**World Forum for Harmonization of Vehicle Regulations****Working Party on General Safety Provisions****122nd session**

**UN Regulation No. 34 (Prevention of fire risk)****Proposal for Supplement 3 to the 03 series of amendments of  
UN Regulation No. 34****Submitted by the expert from the International Organization of Motor  
Vehicle Manufacturers \***

"Model B  
(See paragraph 3.1.5. of this Regulation)

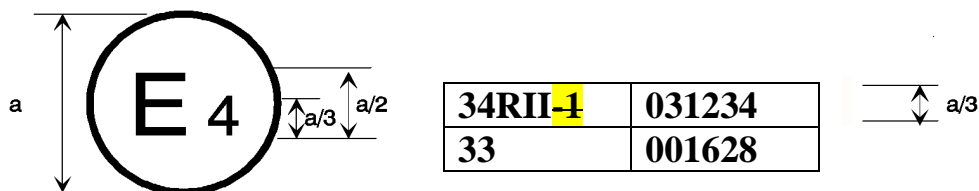
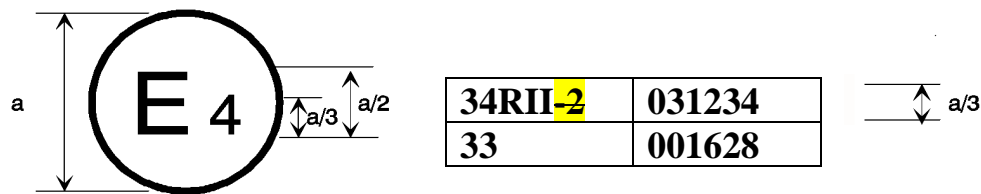
Annex 2, amend to read (changes highlighted in yellow – footnote unchanged):

The above approval mark affixed to a vehicle shows that the type concerned was approved in the Netherlands (E 4) pursuant to Regulations Nos. 34 Parts I or IV and II-1 and 33.\* The approval numbers indicated that, at the date when the respective approvals were given,

The above approval mark affixed to a vehicle shows that the type concerned was approved in the Netherlands (E 4) pursuant to Regulations Nos. 34 Parts I or IV and II-2 and 33.\* The approval numbers indicated that, at the date when the respective approvals were given, ...”
